# Product update

## Energy Server Com'X 510

> June 2015

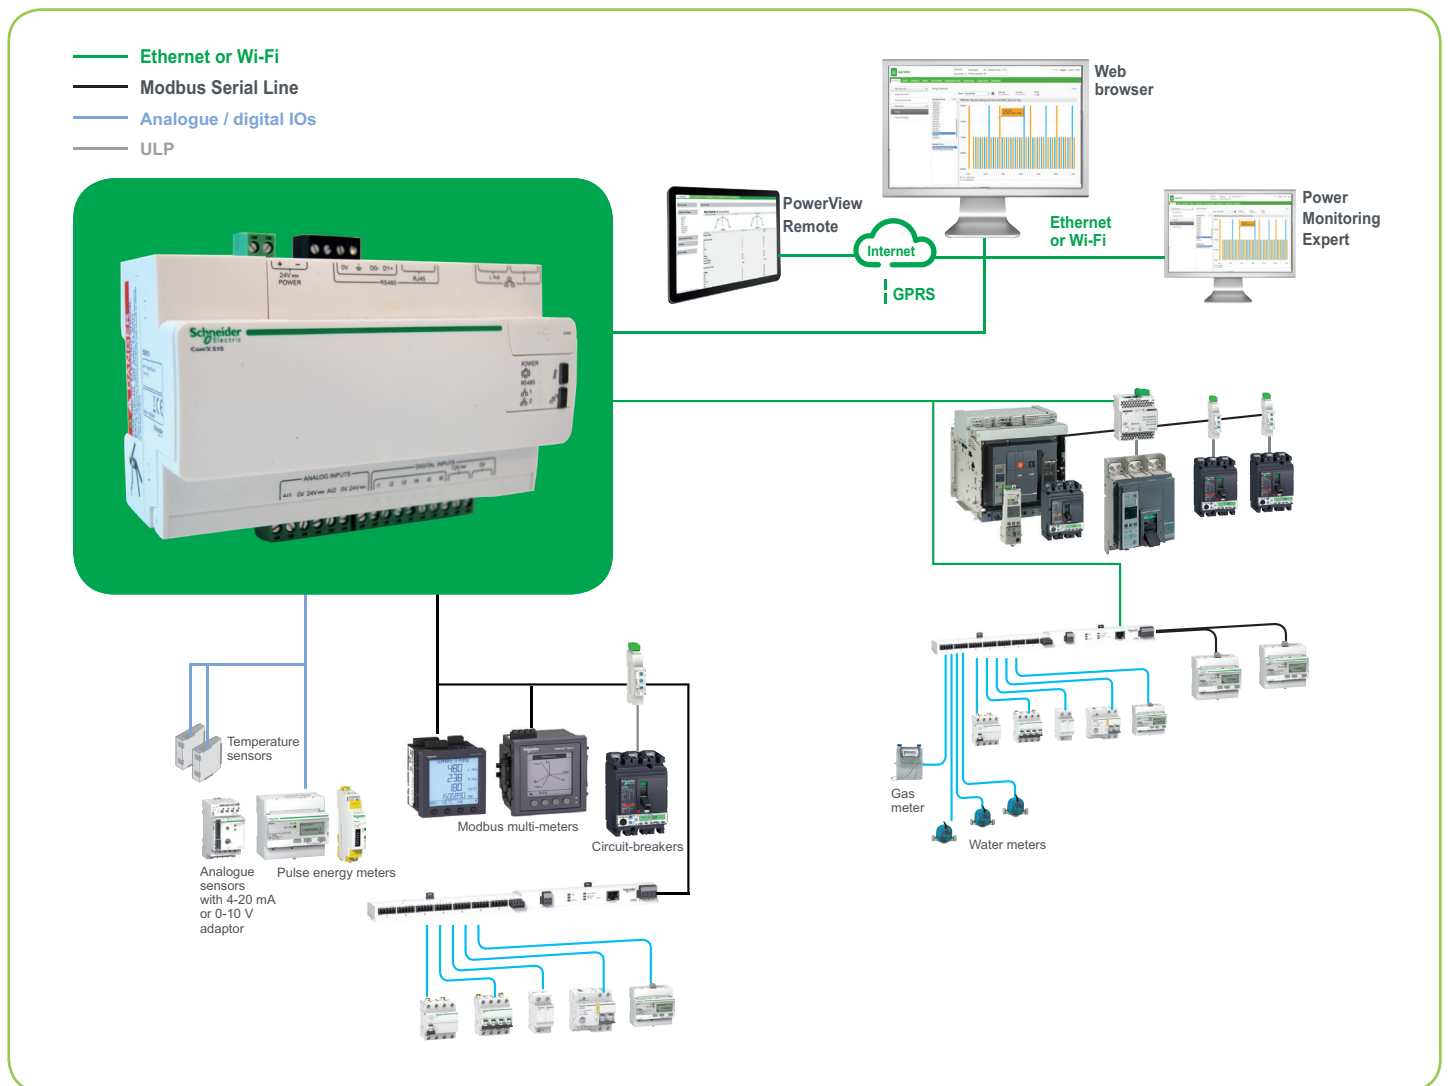
Say hello to the new Com'X 510...all the features of Com'X 200 + EGX300 embedded into an energy management and dashboard in a box.

Obsolete product	Product description	Discontinued date	Replacement
EGX300	Energy-server gateway	March 2016	EBX510
